City of Portland, Maine - Building or Use Permit Application

Permit No: 05-1843	Issue Date: JAN 24 2006	CBL: 392 A007001
-----------------------	----------------------------	---------------------

Location of Construction: 140 HOPE AVE	Owner Name: SHAW LARRY R & KEVIN L SH	Owner Address: 23 LONGWOODS RD	Phone:
Business Name:	Contractor Name: Kevin Shaw	Contractor Address: 140 Hope Ave Portland	Phone: 2077806156
Lessee/Buyer's Name	Phone:	Permit Type: HVAC	Zone: R2

Proposed Project Description: Install a gas fireplace	Signature: JMB 1/13/06
PEDESTRIAN ACTIVITIES DISTRICT (P.A.D.)	
Action: <input type="checkbox"/> Approved <input type="checkbox"/> Approved w/Conditions <input type="checkbox"/> Denied	
Signature:	Date:

SCALE	1/4" = 1'	DRAWN BY	J. CAL
DATE	3/04	PAGE	2 OF 2
NAME		DRAWING	
7 HOPE AVE. PORTLAND		FLOOR PLANS

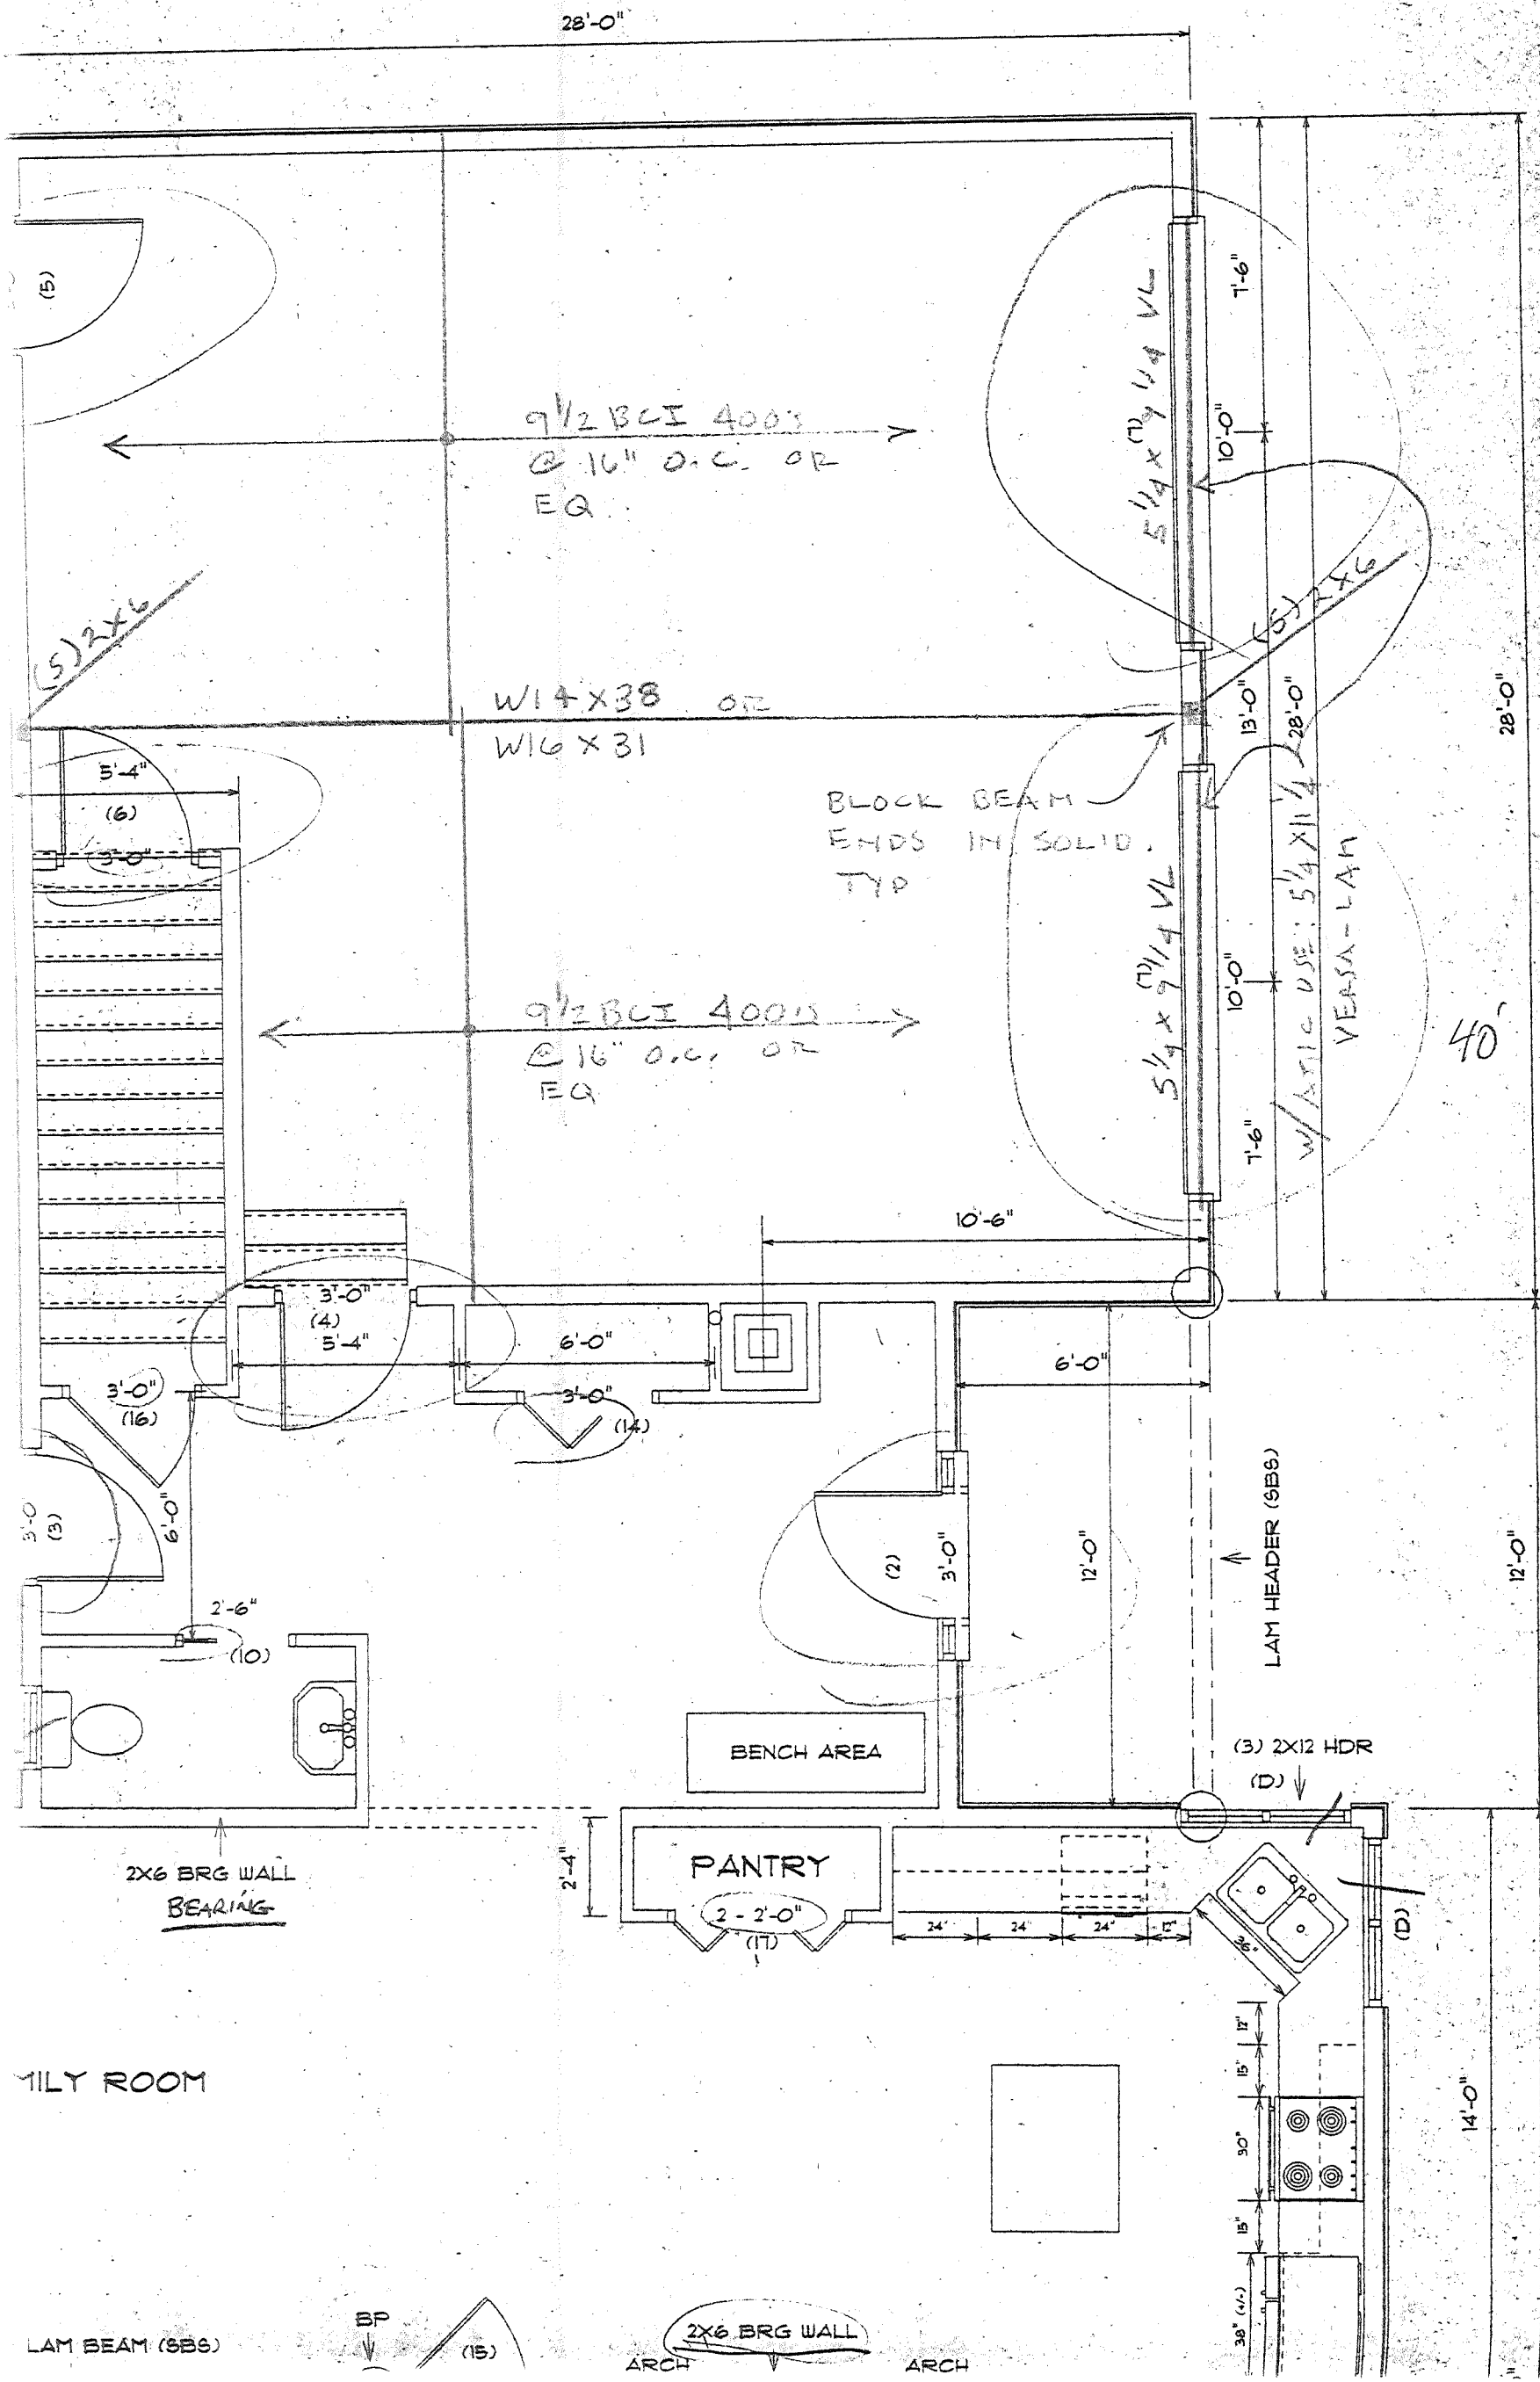
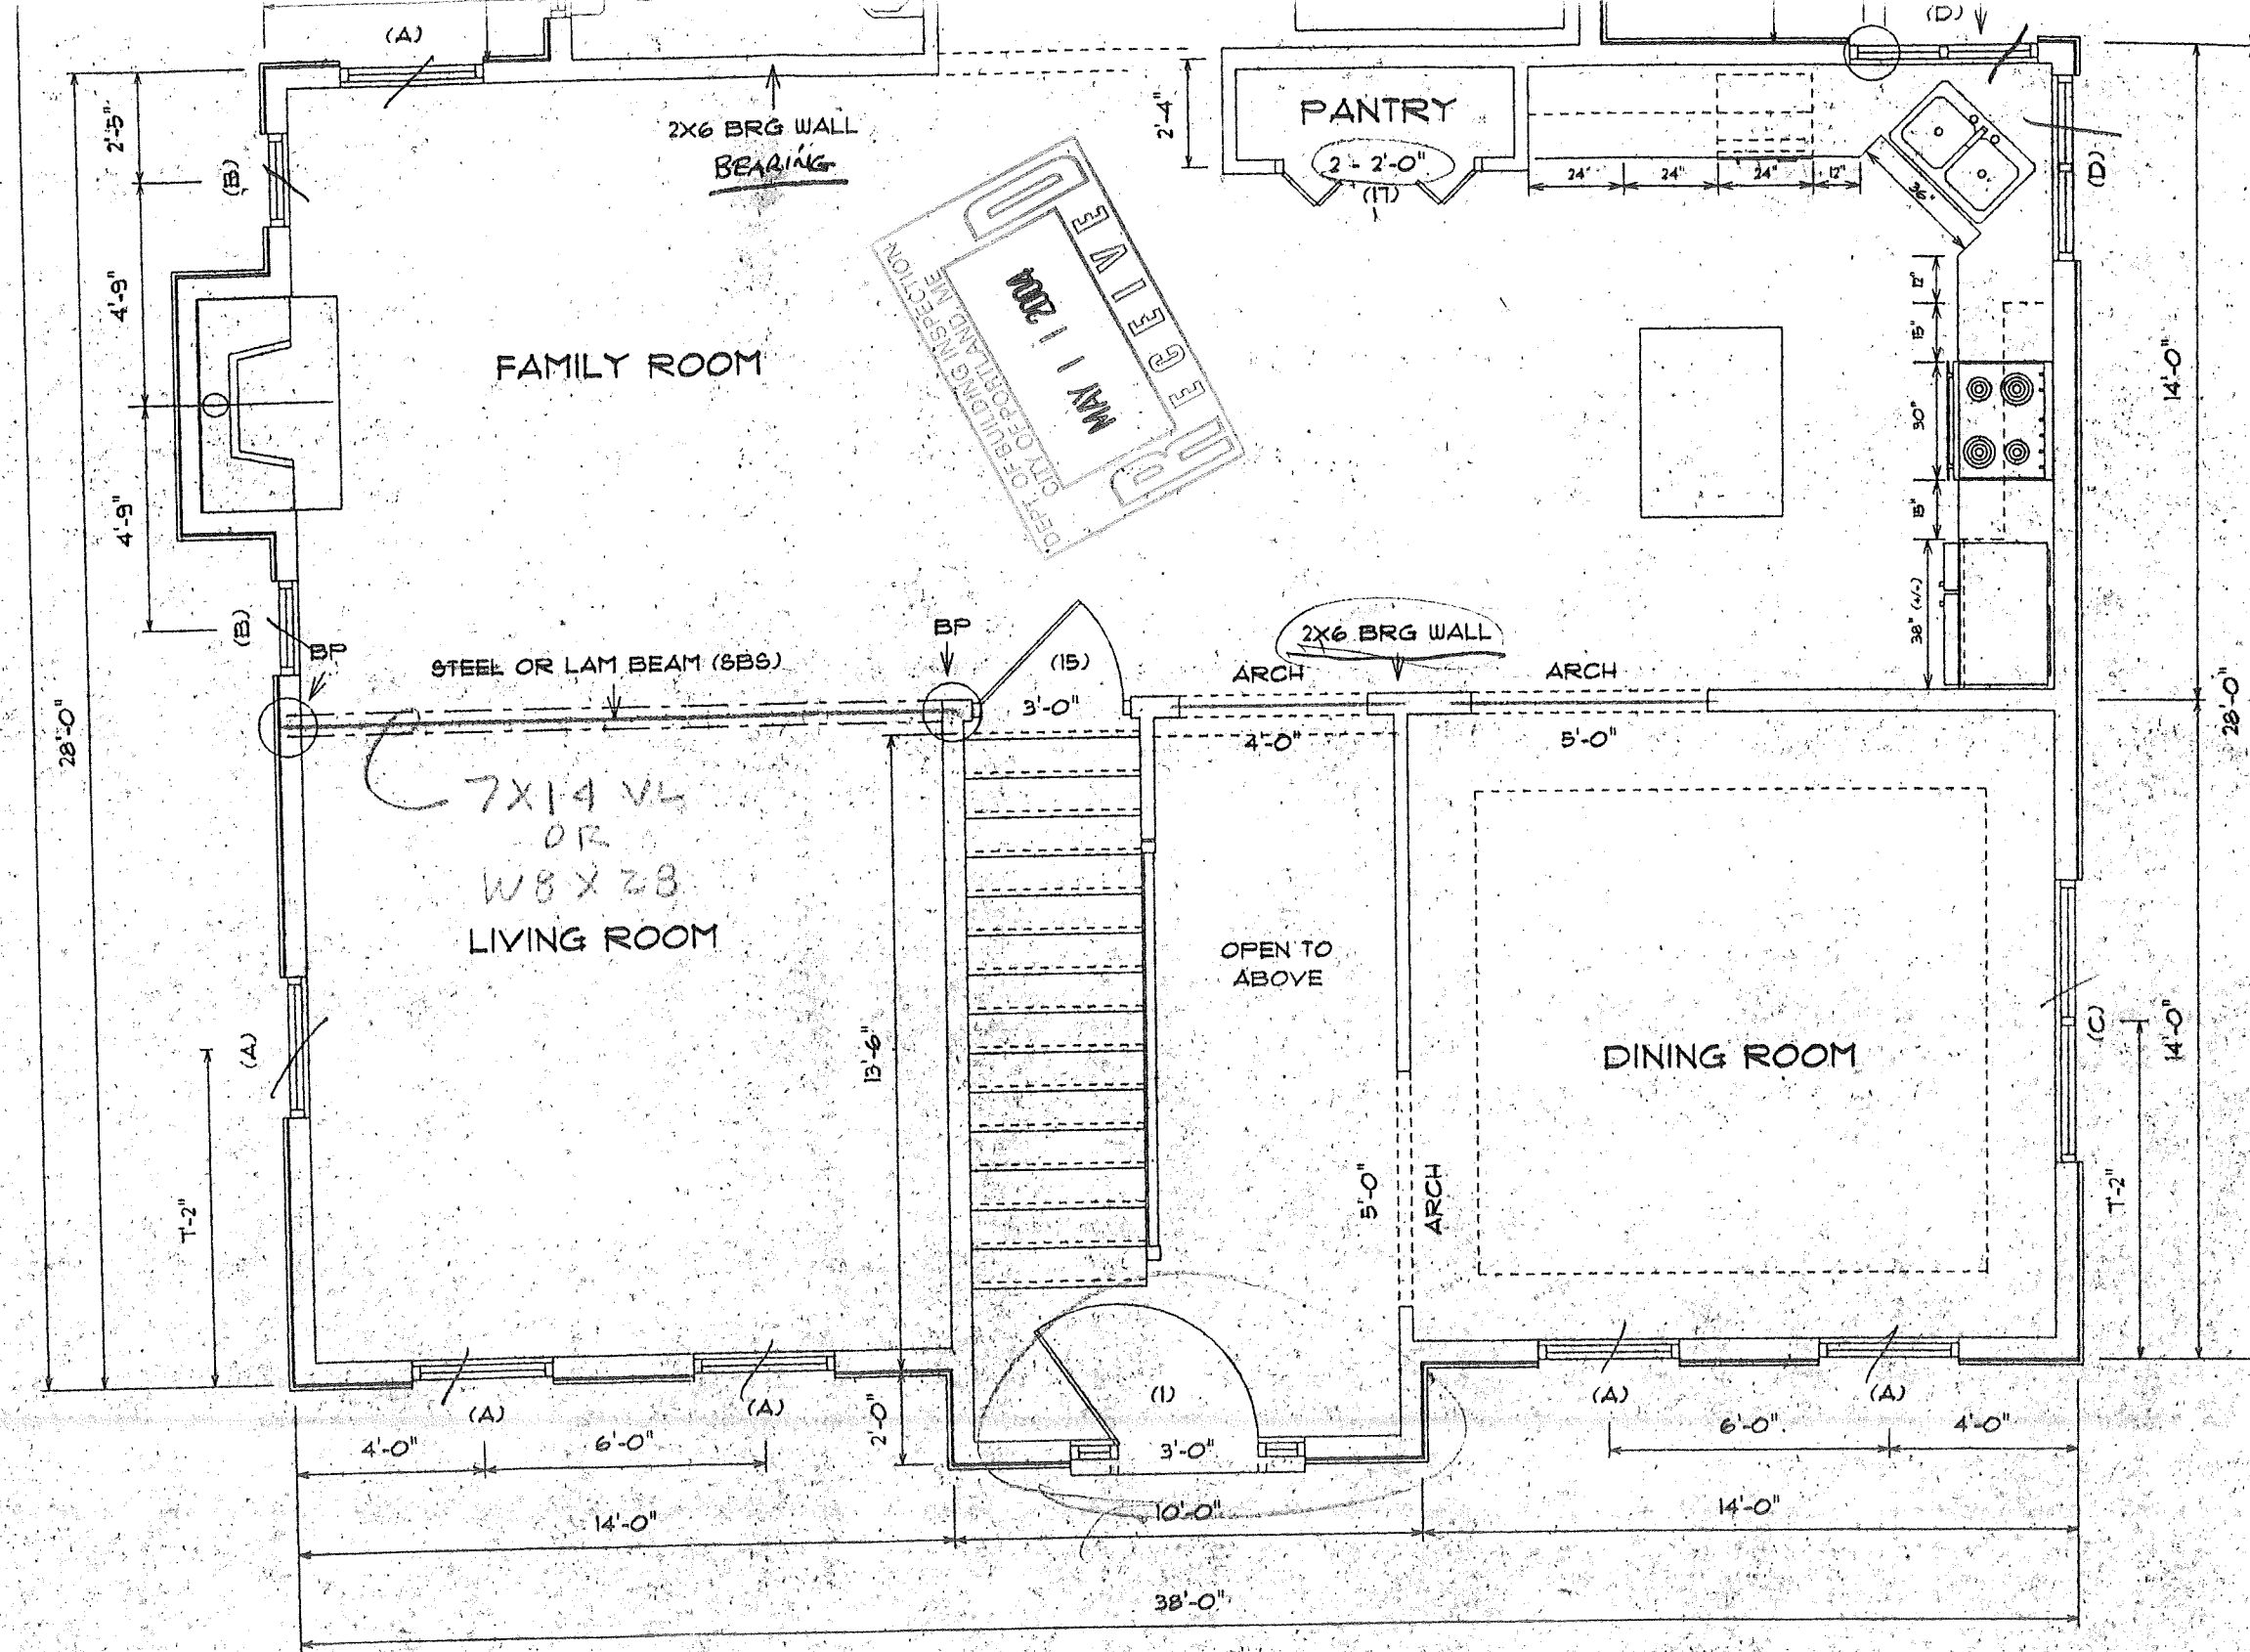
- KS All Bedrooms will have Egress Window & Door
- KS Arch Access to be changed to MIN 82" X 30"
- KS Chimney Clearance MIN 2" to Roof with Flashing at each Floor
- KS All Headers 2x10 ON BEARING WALLS
- KS Exterior Stairs NO MORE THAN 7 1/4" RISE / AT LEAST 10" TREAD
- KS Smoke detectors in all bedrooms / basement / living room / kitchen / breezeway / garage
- KS Anchor bolts to be NO MORE THAN 6" OC
